# Video Products Technical Bulletin 30-2008-027

SUBJECT: **REUSE PARTS WHEN REPLACING THE A BOARD**

MODEL: **PVM-1954Q**  
*PVM-2054QM*

**Figure 1**

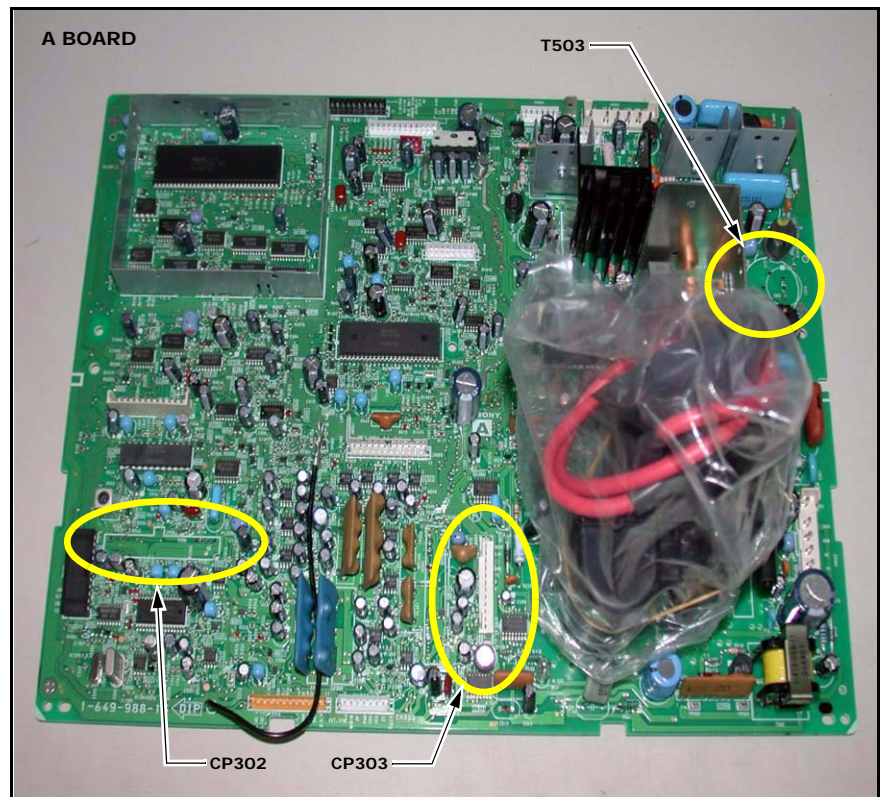
When you replace the A board (A-1297-197-E), remove the following parts from the former board and install them on the new board.

Ref. No.	Description
CP302	Color difference isolation module for PAL
CP303	Com filter block (CFB-4)
T503	Horizontal linearity compensation transformer

The new A board does not contain the parts, and the parts are no longer available. (See Figure 1.)
